Work Order ID 93625

Item Name: Replacement Skidtube

DRAWING NO. D3804	TITLE SKIDTUBE ASSEMBLIES, 206A/B	REV. A	DART AEROSPACE LTD ENGINEERING ORDER		D.E.O. NO. D3804-A-1	SHEET NO. SHEET 1 OF 1	SCALE NTS
DRAWN <i>OP</i>	CHECKED <i>AP</i>	MFG. APPR. <i>[Signature]</i>	APPROVED <i>[Signature]</i>		DE APPR. <i>[Signature]</i>		
DATE 12.10.12	DATE 12.10.22	DATE 12.10.22	DATE 12.10.22		DATE 12.10.22

CHANGE C'BORED WELDED CROSSBOLT SPACERS TO SWAGED SPACERS

AMENDMENT TO DETAIL B
NOT TO SCALE

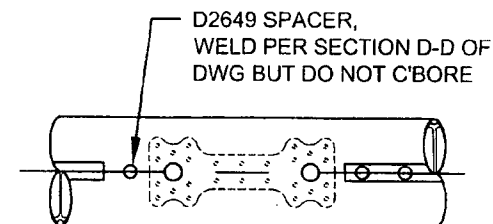
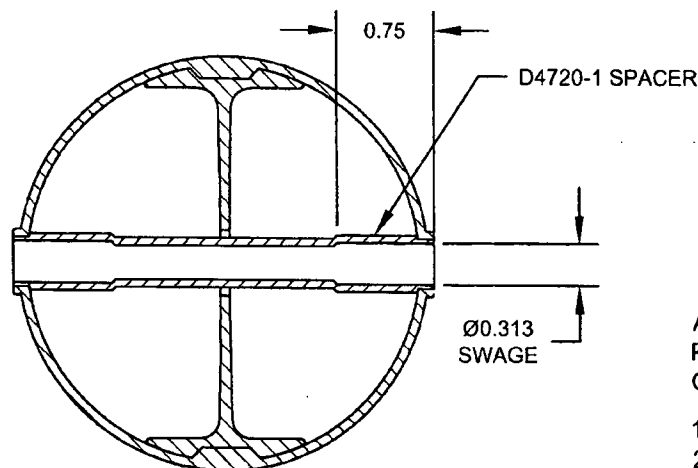
ADD SECTION H-H BELOW, WHICH IS THE SAME SECTION VIEW AS SECTION D-D OF DWG.
C'BORED HOLES ARE **NOW SWAGED** PER SECTION H-H BELOW. FOR THE Ø0.375 HOLE THAT IS NOT C'BORED, WELD PER SECTION D-D OF DWG (SEE AMENDED DETAIL B FOR REFERENCE).
